### Application A2021-09-093 Gilbane - Response to CRMC Comments

THIS PLAN DEPICTS PENDING CRMC FILE #A2021-09-093

JOB NO. 3525	DRAWN BY: R.L.C.
DWG. NO. 3525-DCK	CHECKED: M.L.D.
SCALE: AS NOTED	APPROVED: W.D.D.
SHEET: 1	DATE: SEPT. 24, 2021

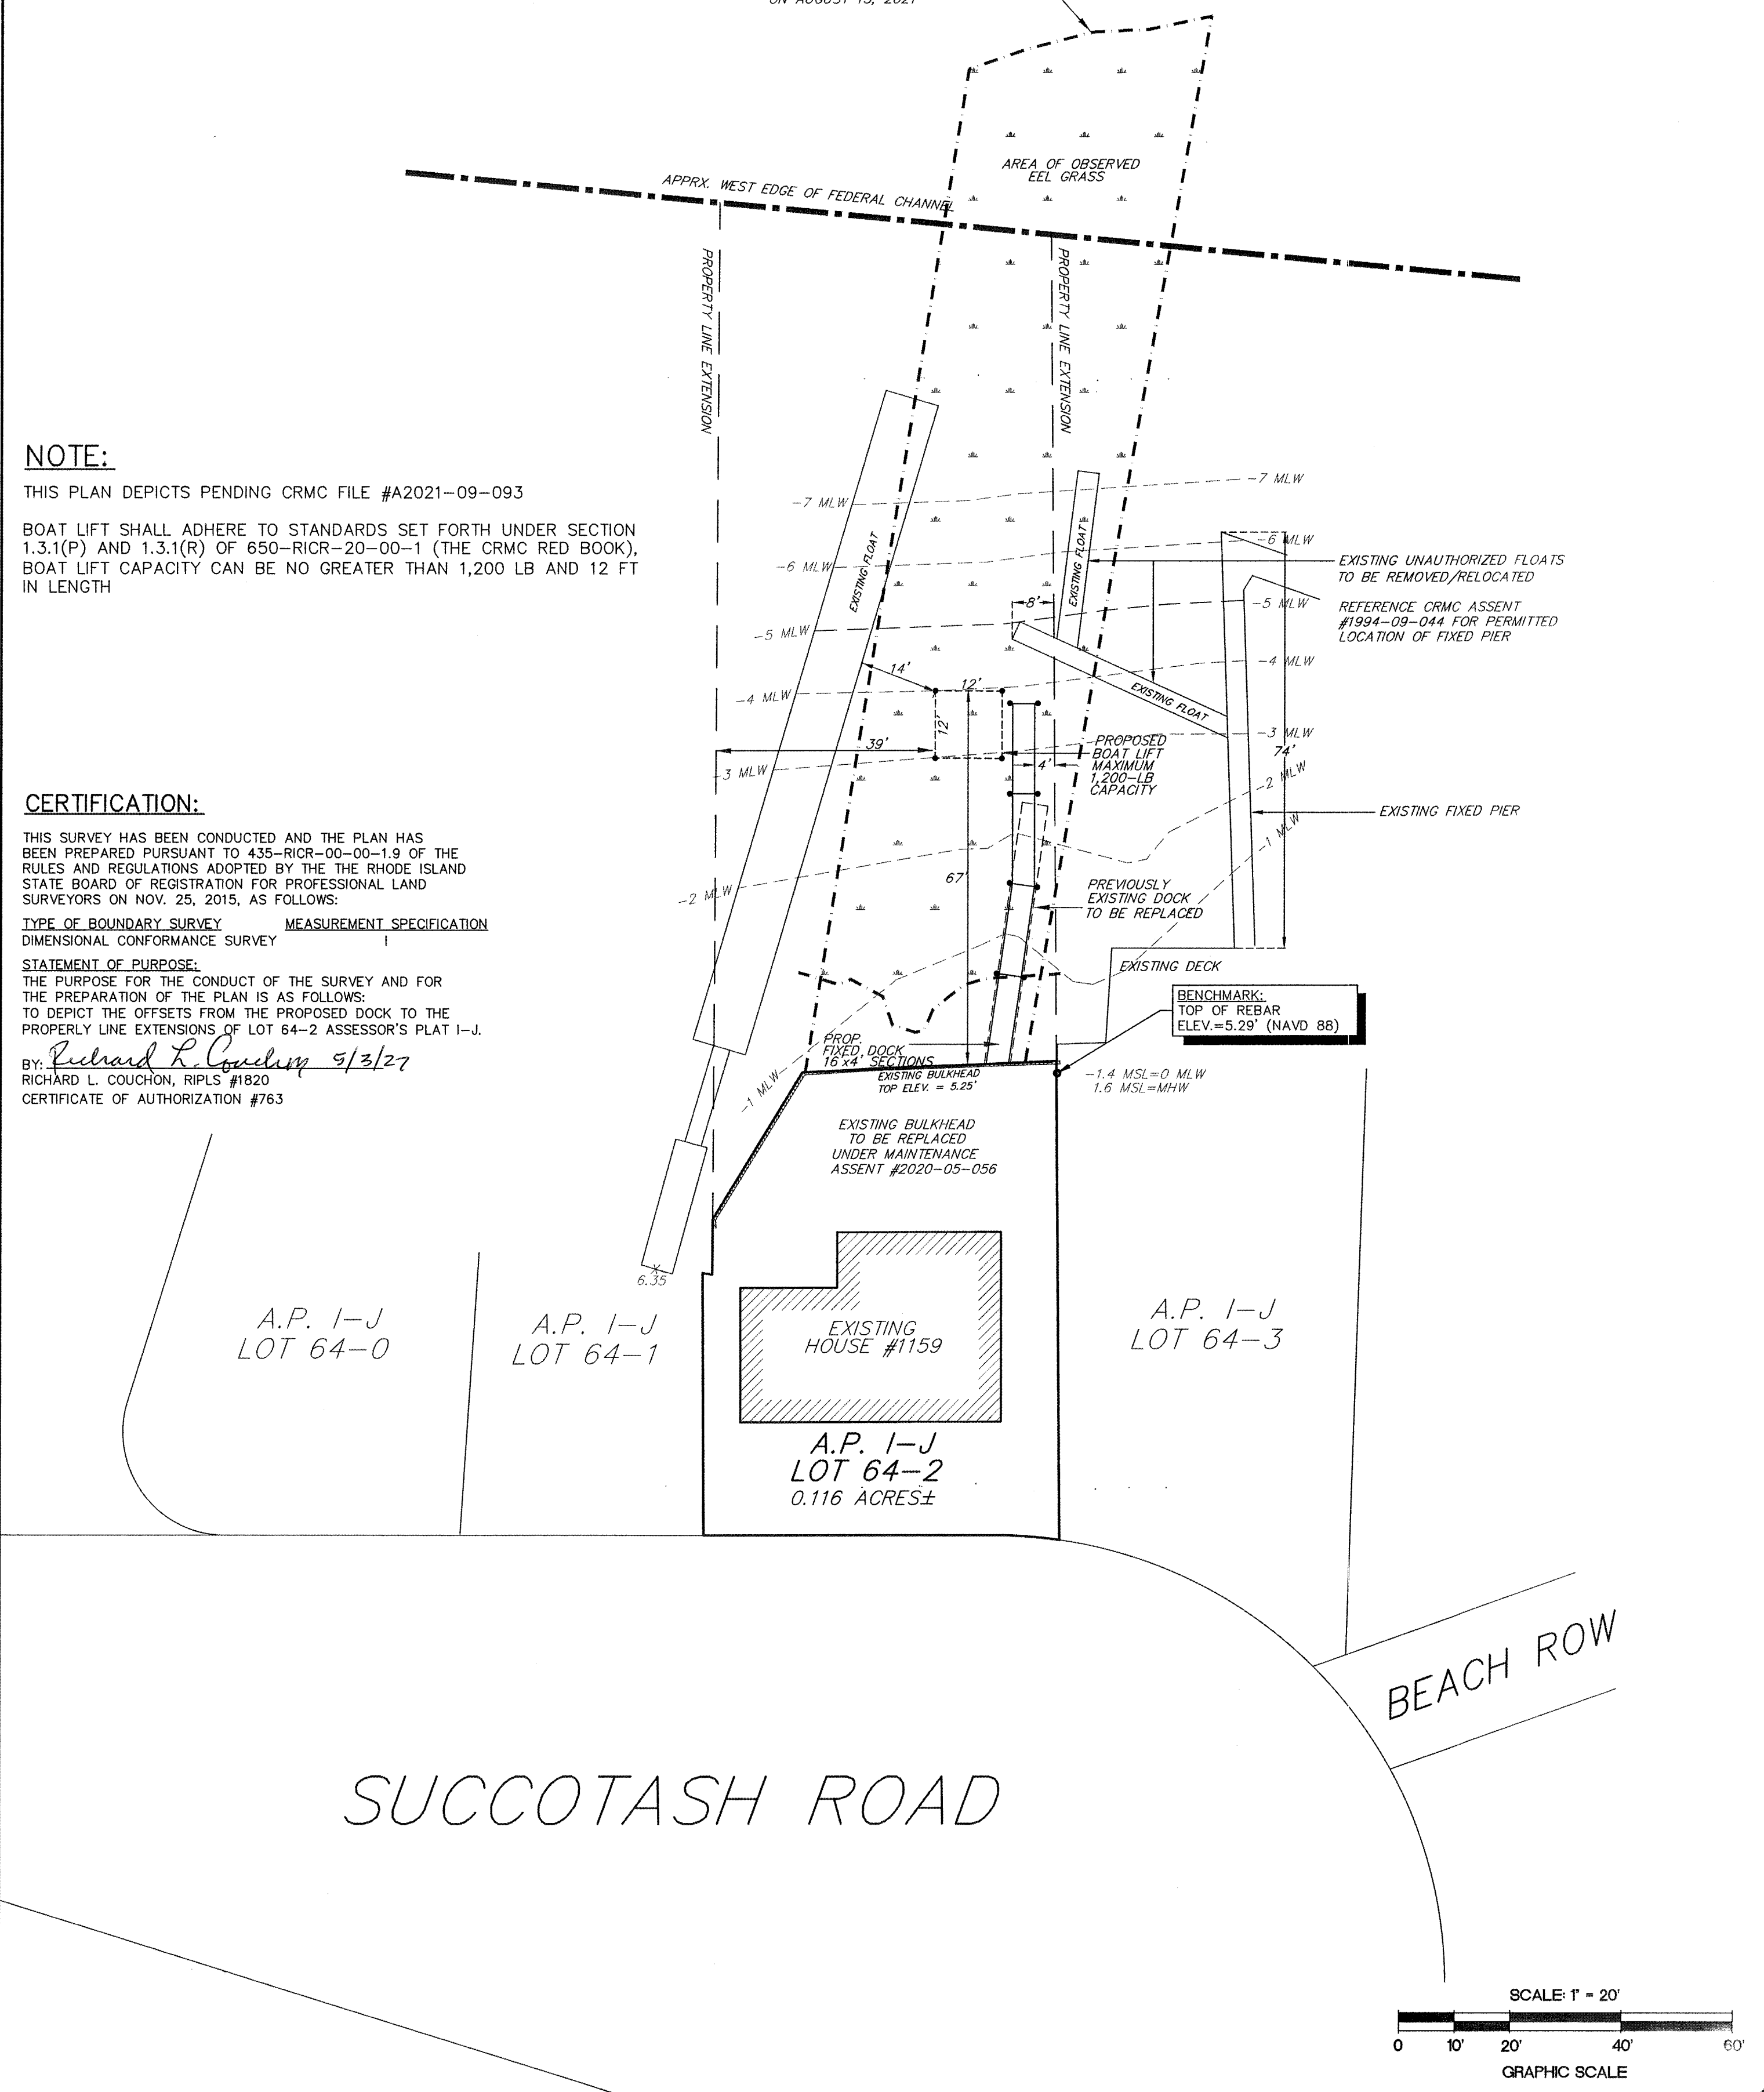
Additionally, traditionally boat lifts over SAV are limited to ~~42,000lb~~ 12ft length/1200lb, my typo tender and touch and go only--please review Section 1.3.1(R) as this is a prohibition which a variance cannot be applied for. Staff cannot support a lift capacity greater than stated. Additionally, please review and certify that the standards of the boat lift section (1.3.1(P) are met in the chosen design.

They also require a minimum 4' water depth, which is more consistent with your current depth proposal.-Staff can support your variance requests relative to current proposed length/water depth.

**PLANS UPDATED TO SHOW MAX 1200LB, 12FT LONG LIFT.**

BOAT LIFT SHALL ADHERE TO STANDARDS SET FORTH UNDER SECTION 1.3.1(P) AND 1.3.1(R) OF 650-RICR-20-00-1 (THE CRMC RED BOOK), BOAT LIFT CAPACITY CAN BE NO GREATER THAN 1,200 LB AND 12 FT IN LENGTH
